## TVA142 Crosstalk Reduction Kit

Part Number 0040-1429

A design improvement has been made on the TVA 142 and TVA142-1, improving the "off-channel attenuation." Due to the characteristics of the LED/LDR optical coupler used for audio switching, the high frequency attenuation was poor at best. The problem is generally apparent as tape rewind noise leaking to the program bus. The combination of high level and high frequency makes the problem apparent with rewinding tapes, but not with normal program audio.

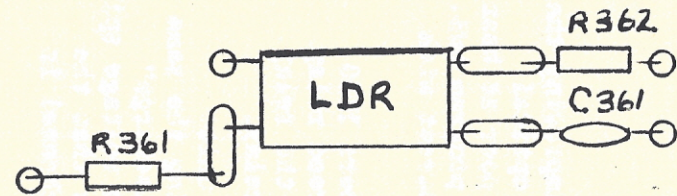
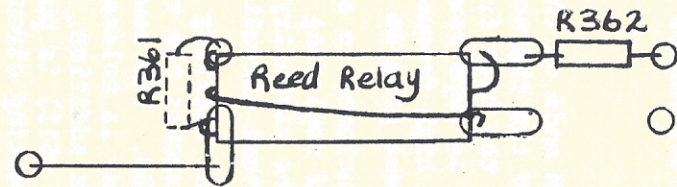
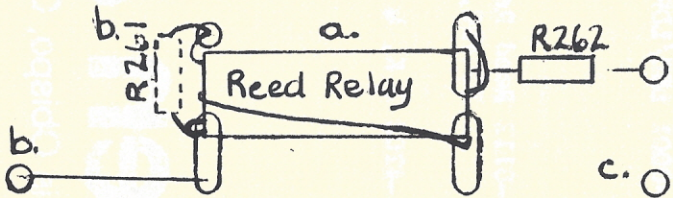
↓ change all LDR's  
in this column

↓ change all LDR's  
in this column

a) Reed Relay's replace LDR's. Leads will need to be bent inward under Relay's to fit.

b) Resistor R261 changes from a  $560\Omega$  series current limiting resistor to a  $2K$  shunt resistor which is soldered on the bottom of the board.

Jumper wire replaces series current limiting resistor R261.

c) Capacitor C261 is deleted.
